**BROOKS LANDING - PHASE II PUBLIC IMPROVEMENTS**  
**CITIZEN ADVISORY COMMITTEE MEETING MINUTES - MEETING #4**  
**SEPTEMBER 13, 2010 - GENESEE WATERWAYS CENTER**

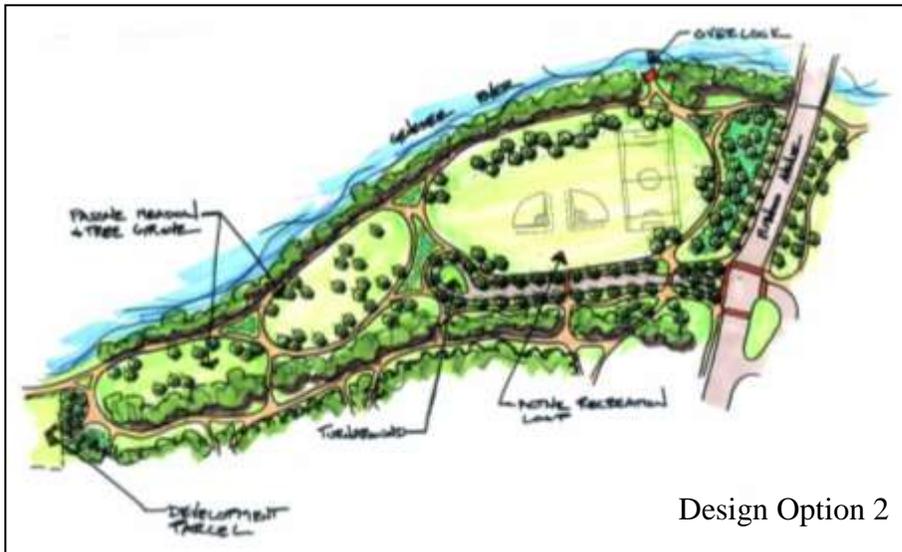
The current roadway connection does not align with the approved access easement placed over the drive aisle of the hotel parking lot. In order to design a roadway connection that conforms to roadway design guidelines and aligns properly with the access easement, a number of trees will need to be removed from the area south of the hotel parking lot (see image left). This is necessary because the slope will need to be re-graded in order to accommodate a roadway that is less steep than the current connection, and connects to the hotel parcel on axis with the drive aisle of the parking lot to align with the public access easement. The graphic at left was presented

to the CAC in order to illustrate the area where tree removal and grading will occur in order to realign the roadway. The impact area was also shown in the field during the site walk.

There was a mix of feelings with regard to the two options. Some felt that maintaining a vehicle connection between Elmwood Avenue and the hotel property was important to fuel economic development in the neighborhood, for vehicular access to the park and as an alternate route to avoid traffic on Genesee Street heading south to Elmwood. Many neighbors currently use the existing connection citing that it at times can be

difficult to take a left onto Genesee Street, and instead take a right thereby using the internal park road to access Elmwood Avenue. Some members of the CAC that are also adjacent residents were concerned about the potential impact of design option 1, as further loss of trees and wildlife habitat is something they had hoped to avoid. The proximity of the realigned roadway to neighboring housing was also a serious concern. Concerns were also expressed regarding design option 2, that the turnaround loop may take up too much lawn area; however, the decision regarding whether or not to maintain a vehicular connection through the park appears to be the most controversial topic. Some members of the CAC seemed to support the idea of not providing a vehicular connection, while others feel that the traffic calming measures proposed will be enough to slow cars and discourage cut-through traffic, allowing a connection to be made. Those present for the walk were evenly split 3/3 for and against the vehicular connection.
